Submission on Modification to Vincentia District Town Centre - Stage 1 - MP  
06\_0025 MOD 5

The Vincentia Ratepayers and Residents Association is the council-recognised community consultative body for the Vincentia District Centre (VDC) project location.

## **2.4 NW Entrance**

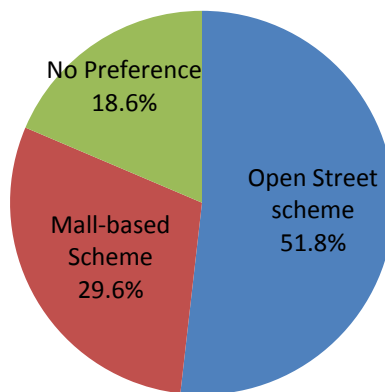
Moona Creek Rd entrance point to the Naval College Rd roundabout increases the likelihood of traffic congestion on Naval College Rd. A similar planning problem is encountered in South Nowra where McDonalds and Caltex are situated close to the Princes Hwy roundabout and queuing traffic backs up into the highway.
